# Program Bulletin

## CUSTOMER SATISFACTION PROGRAM

**SUBJECT:** Power Steering Hose Leak

**MODELS:** 2006 Chevrolet Impala, Monte Carlo (V6 & V8 Engine)  
2005-2006 Pontiac Grand Prix (V8 Engine)

1854948

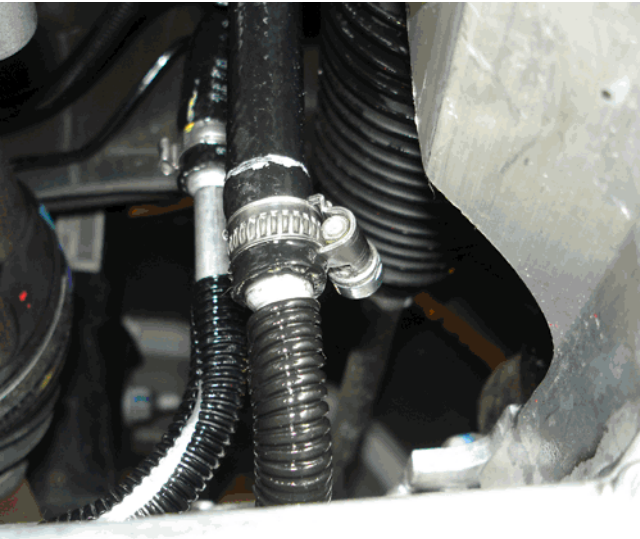
**Note:** The location of the leak (1) is shown above. The power steering cooler hose may leak from the hose clamp.

1. Raise and support the vehicle. Refer to the *Lifting and Jacking the Vehicle* procedure in SI.
2. Place a drain pan under the repair area.
3. Remove the power steering hose clamps.
4. Remove the power steering hose from the vehicle.

1854947

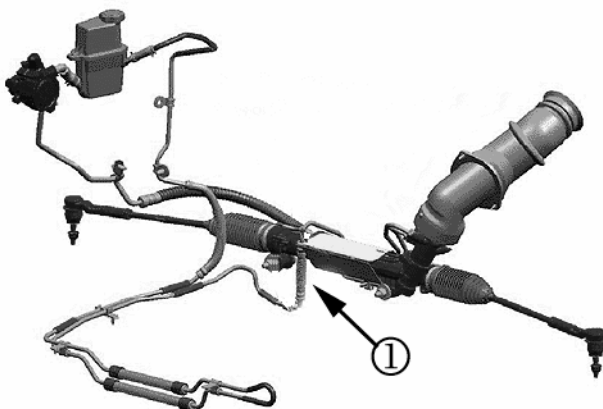
**Note:** The location of the leak (1) is shown above. Fittings on the hose are crimped socket and are not likely to leak.

**Note:**

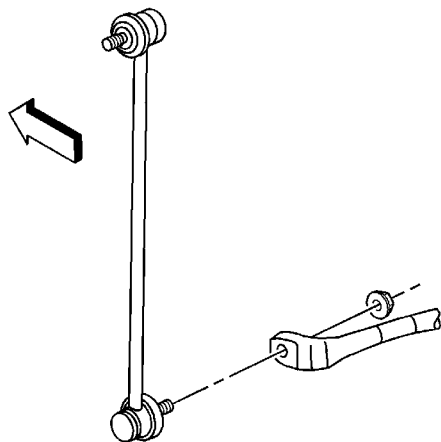
- Two holes will be drilled for retro-fitting 2006 cradles with 2007 cooler pipe.
- Technician will need to remove one clip from cooler pipe on top and replace with isolator, and move the other to the front face of the cradle (and replace with isolator).
- Technician will need to glue down the two isolators with Instant Adhesive-Gel, P/N 12345632 (US), 10953475 (CN), or equivalent, such as SAF-T-LOK IB-45 (ETHILCIANOCRILATO).

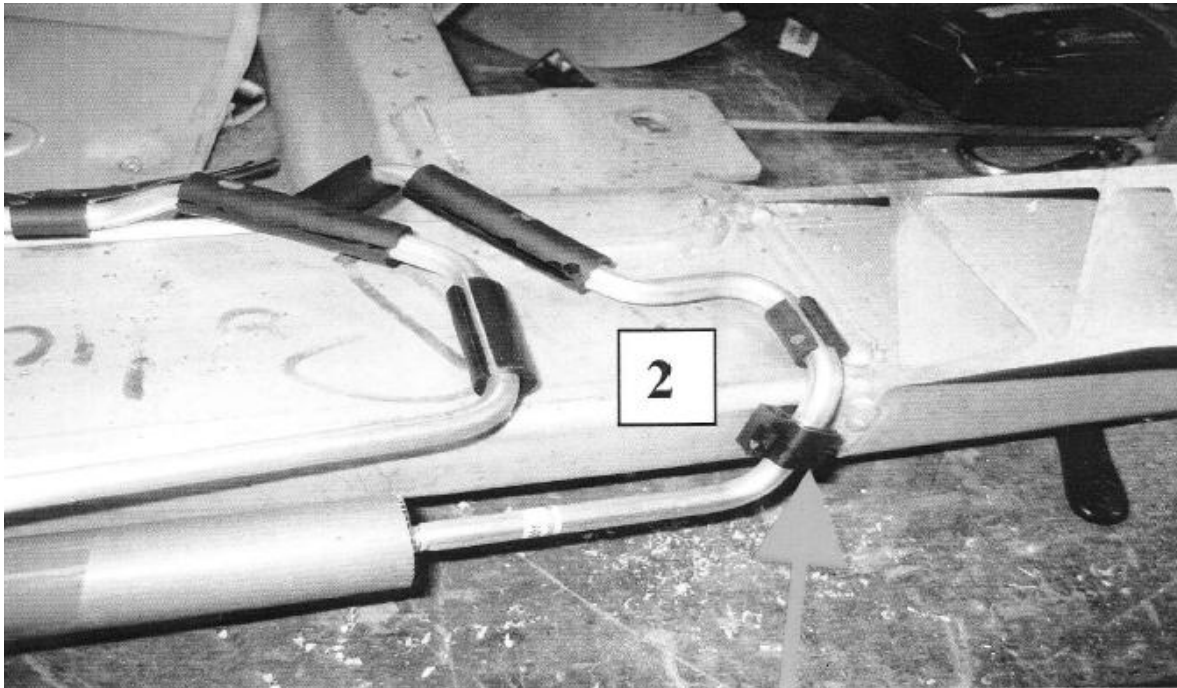
22. Remove the clip and replace with glued isolator (1). Isolator is smaller than what picture shows.

**Note:** Glue should be Instant Adhesive-Gel, P/N 12345632 (US), 10953475 (CN), or equivalent, such as SAF-T-LOK IB-45 (ETHILCIANOCRILATO).

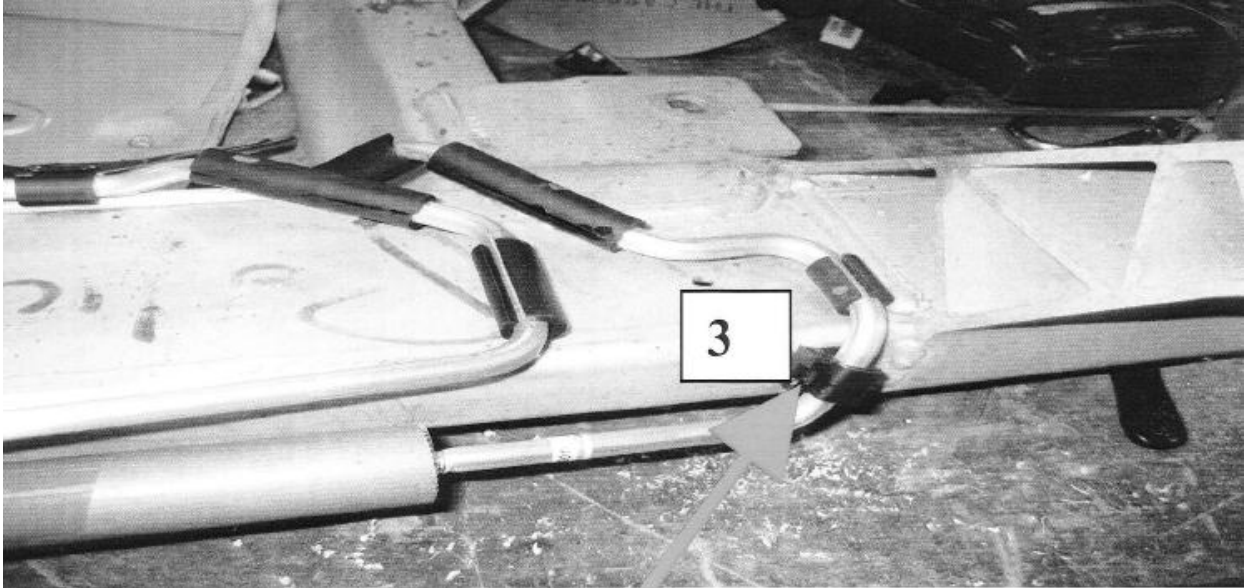
23. Move the other clip to the front of the cradle and replace with glued isolator (2).

**Note:** The hole should be drilled using a 7/32 in drill bit and is located 402mm (15-13/16 in) from the weld and 19 mm (3/4 in) from the top of the cradle. The z-bracket should be riveted to the cradle using part number 10125439 (instructions sheet may show part number 11516301, but it may not be available).

24. Drill a hole in the cradle through the z-bracket.
